Response to Open Issues

-
1. Mass Error vs. Time
 2. Number of Mesh Point of the Heat Structures for Lower Head and Vessel Wall
 3. Vessel Wall Temperature
 4. Heat Structure Mesh Size
 5. Junction Control Flag in Break Valve

4. Heat Structure Mesh Size

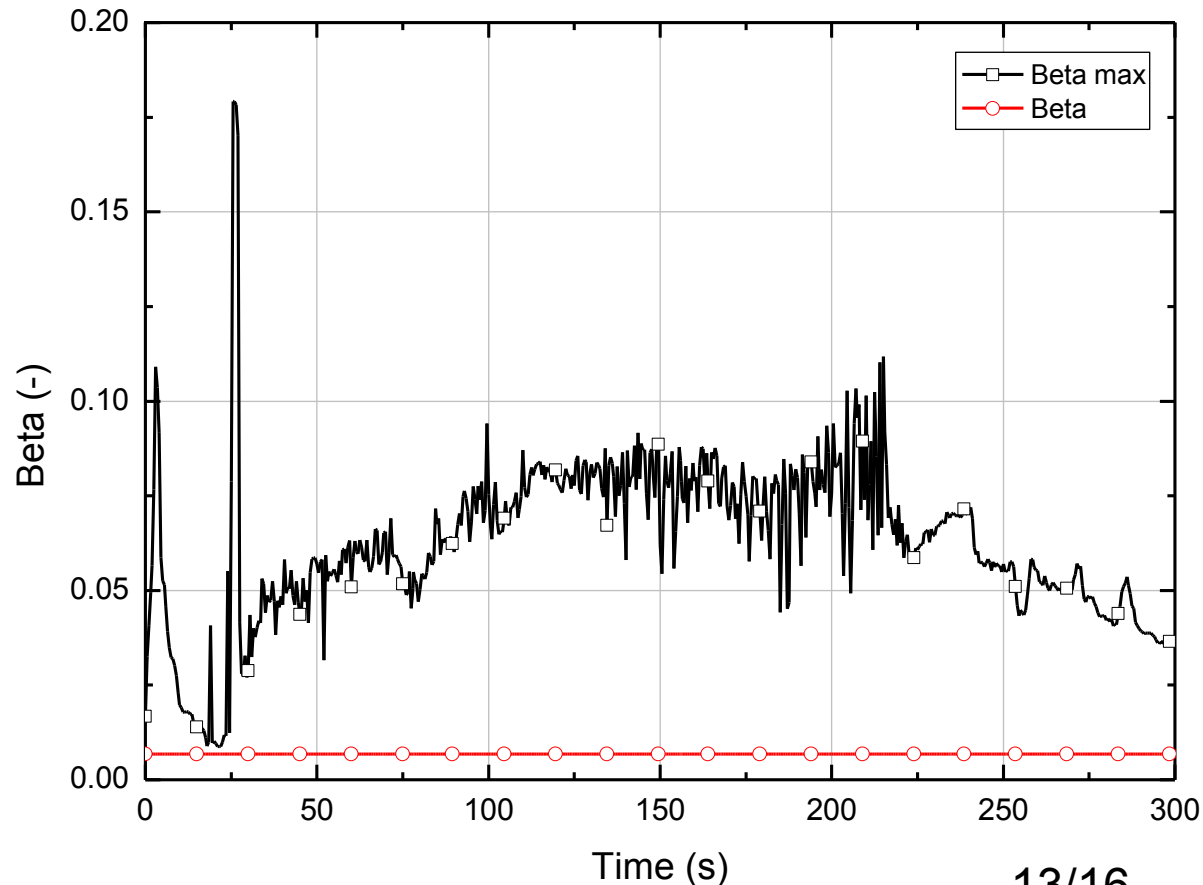
- Heat structure mesh size of APR1400 vessel wall following β definition is

$$\checkmark \quad \beta = \frac{0.5 * x}{L} = \left(\right)^{TS}$$

$0.5 * x$: one half of the first mesh interval
 L : wall thickness

- RELAP5-3D heat structure mesh guide line states,

$$\checkmark \quad \beta \text{ should be smaller than } \beta_{max}$$

$$\rightarrow \frac{1}{\beta_{max}} = 0.338Bi + 5.2, \text{ where } Bi = \frac{hL}{k}$$

- As shown in the figure below, β is always lower than β_{max} during the transient. Therefore, current mesh interval size is allowable.
